Marlboro BRF 010-1 (43) RIGGING PLAN

This rigging plan utilizes the DEMAG AC-120. We have previously submitted both pictorially the AC-120 and the AC-160, but only showing the AC-120 capacities on the plan. Our crane schedule has been very dynamic over the last month and for see it being this way right up until October 1st. We have shown again the AC-120 being used to set the beams as this will be the worst case scenario. We have added concrete blocks to the plan to distribute the load near the abutment. The blocks have put the load path below the abutment. Outrigger point loads and distribution calculations are included. Sketches' showing how the centerline of gravity is measured on the paired beams is included. Also the stability analysis has been shown for the paired beams.

SECTION- CONCRETE TOWERS
CRANE NOT SHOWN FOR CLARITY
DO NOT SCALE

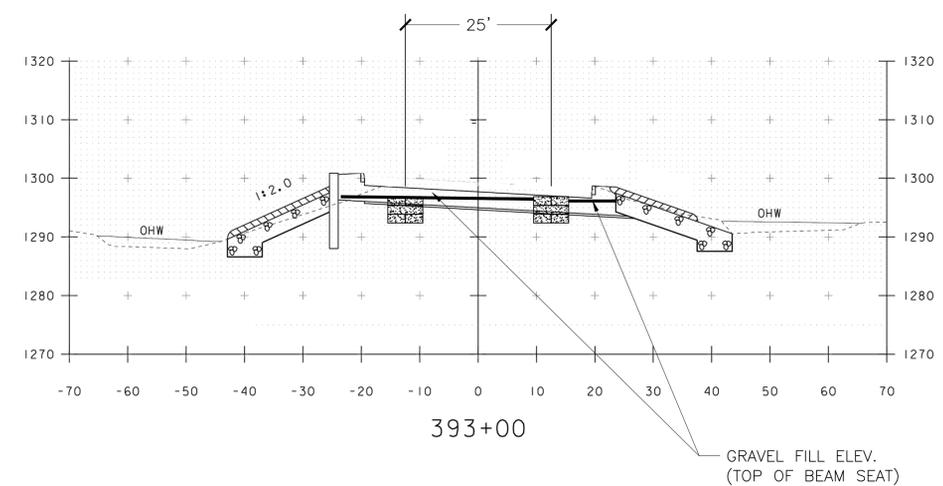
REVIEWER NOTE:

- 1) CONCRETE WASTE BLOCKS HAVE BEEN ADDED TO ELIMINATE THE SURCHARGE LOAD AGAINST THE BACK OF THE ABUTMENT.
- 2) BLOCK TOWER WILL BE 4'-6" IN HEIGHT. EDGE OF TOWER WILL BE AT 5' FROM REAR OF ABUTMENT WALL.
- 3) BACKFILL BEHIND THE ABUTMENT WILL BE AT OR BELOW THE ELEVATION OF THE BEAM SEATS.
